Model: MET-C2.1yz	Date: 10-Feb-17	No.: RD0AH001f
-------------------	-----------------	----------------

Subject: New model release information: MP C3004ex/3504ex/4504ex/5504ex/6004ex, MP C2004ex/2504ex		Prepared by: A.Shigeta	
From: 1st Tech Service Sect., MFP/P Tech Service Dept.			
Classification:	<input type="checkbox"/> Troubleshooting	<input checked="" type="checkbox"/> Part information	<input type="checkbox"/> Action required
	<input type="checkbox"/> Mechanical	<input type="checkbox"/> Electrical	<input checked="" type="checkbox"/> Service manual revision
	<input type="checkbox"/> Paper path	<input type="checkbox"/> Transmit/receive	<input type="checkbox"/> Retrofit information
	<input type="checkbox"/> Product Safety	<input type="checkbox"/> Other ( )	<input type="checkbox"/> Tier 2 <input type="checkbox"/> Tier 0.5

With the release of the new model for successor of MP C3004/3504/4504/5504/6004 and MP C2004/2504, this RTB was released to announce differences between the predecessor models and the new models.

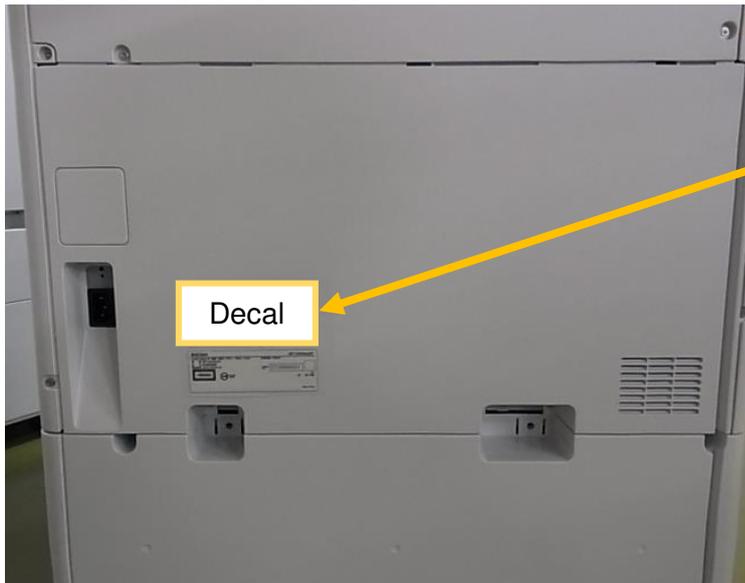
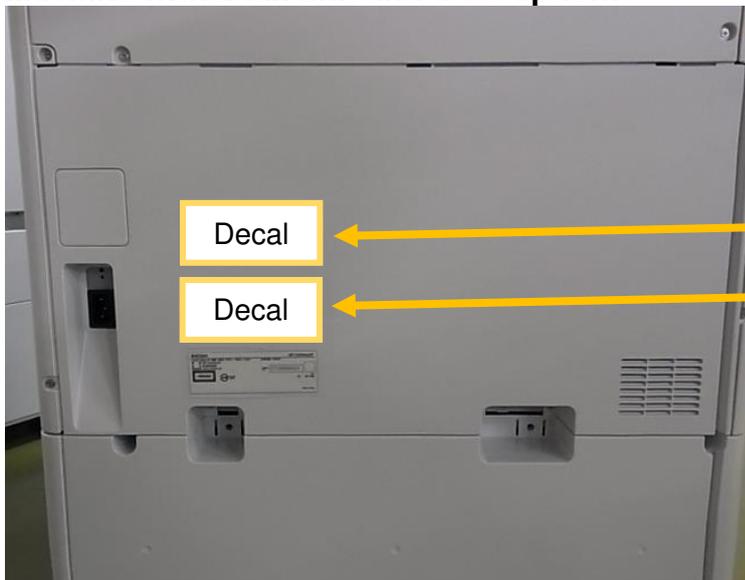
- The decal used to be attached to the bracket inside the machine at the factory until March 2017, but the revised regulation obliges us to attach it to the outer cover.

- Before the modification, the G3 option contained a decal for the double G3 boards as an accessory and another decal attached to the bracket. After the modification, two decals will be included as accessories.
- If the cover has to be replaced, reattach the decal(s) to the same position as shown below.

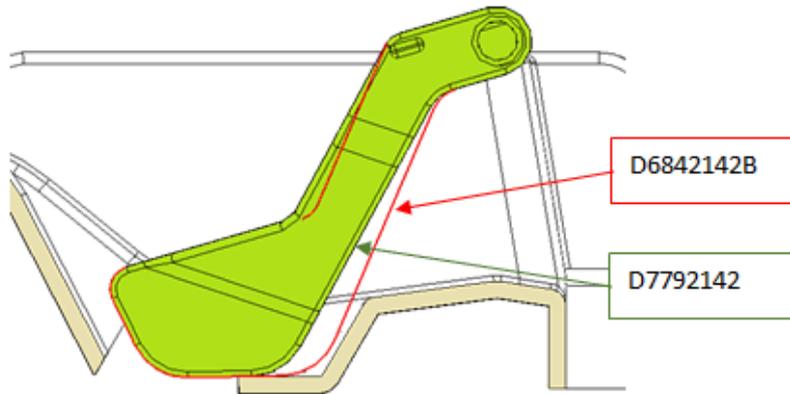
The shape of the feeler was changed.

Replace the feeler with the modified part.

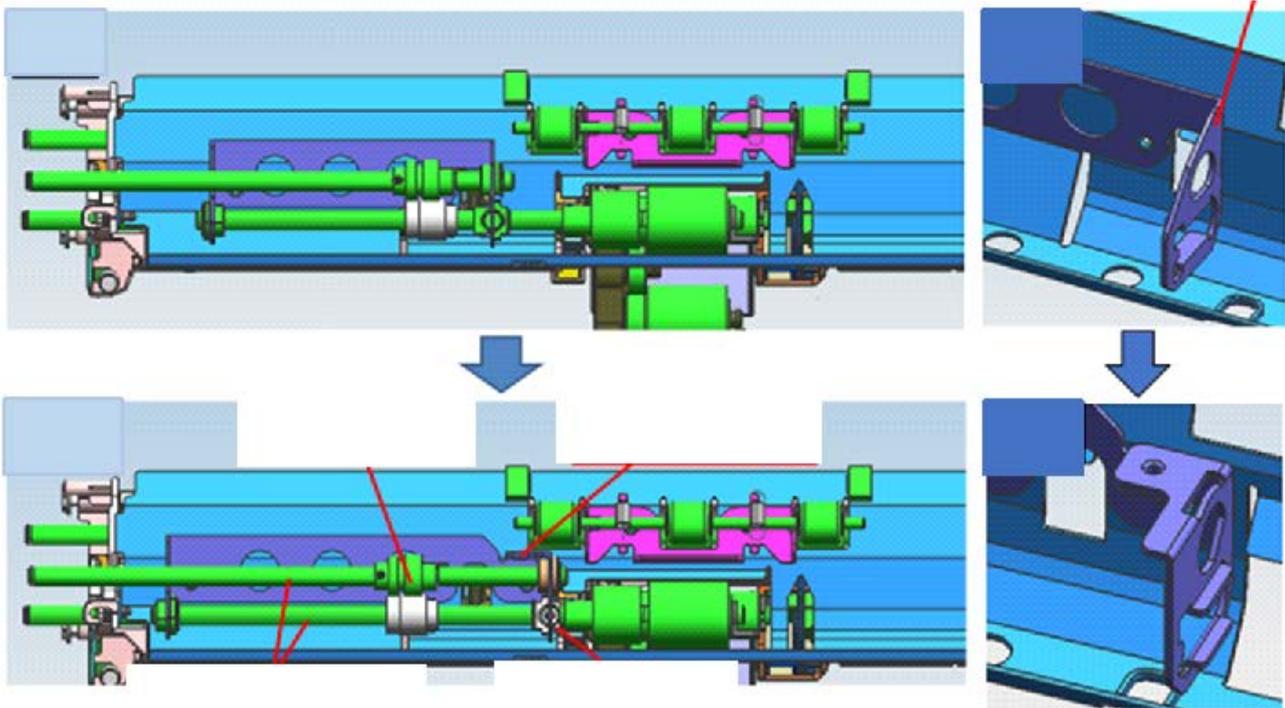
**Change 3:** The shape of the brackets and bearings, length of the roller shaft, and the gear position has changed. Also e-rings added.

Old P/N <Group B>	New P/N	Description	Int	Q'ty	Note
08050104	08050104	RETAINING RINGS-E:SILENCER:DIA4	-	2->3	C
D1494770	D0BQ2608	SHAFT:SEPARATOR:DRIVEN:ASS'Y	X/X	1	C
M0BW2615	D0BQ2615	GUIDE PLATE:SEPARATOR:ASS'Y	X/X	1	C
D1492619	D0BQ2619	SHAFT:SEPARATOR:DRIVE:ASS'Y	X/X	1	C
D2412653	D0BQ2653	COIL SPRING:PRESSURE:SEPARATOR	X/X	1	C

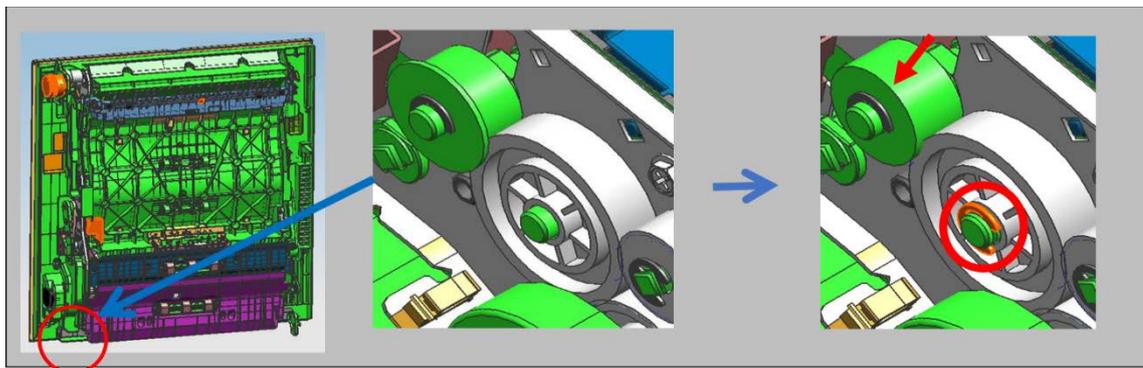
**Change 4:** There are no protruding parts to hold the gear. An e-ring added to stop the gear in position, and a groove added to the shaft for the e-ring.

Old P/N <Group B>	New P/N	Description	Int	Q'ty	Note
07200040E	07200040E	RETAINING RING - M4	-	3->4	D
D2414631	D0BQ4631	SIDE PLATE:REAR:DUPLX:PEEN	X/X	1	D
D2414644	D0BQ4644	GEAR:MECHANICAL ROLLER CLUTCH	X/X	1	D

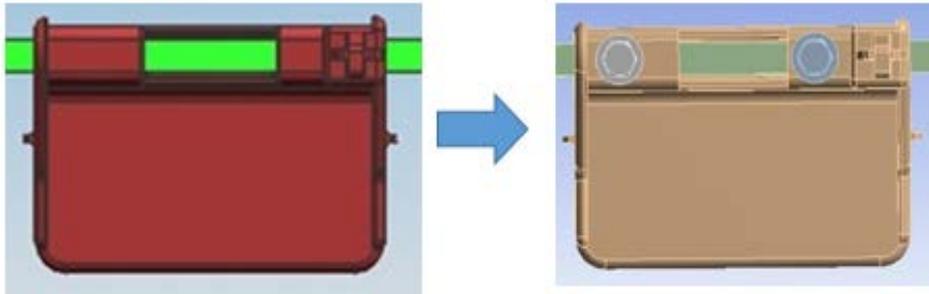
**Change 5:** The grip of duplex unit has been changed from press fit to screw type.

Old P/N <Group A/B/D>	New P/N	Description	Int	Q'ty	Note
-	03603006N	SCREW - M3X6	-	0->2	E
D1754654	D0BQ4654	SHAFT:LEVER:LOCK	X/X	1	E
D1494655	D2894655	GRIP:DUPLEX UNIT	X/X	1	E
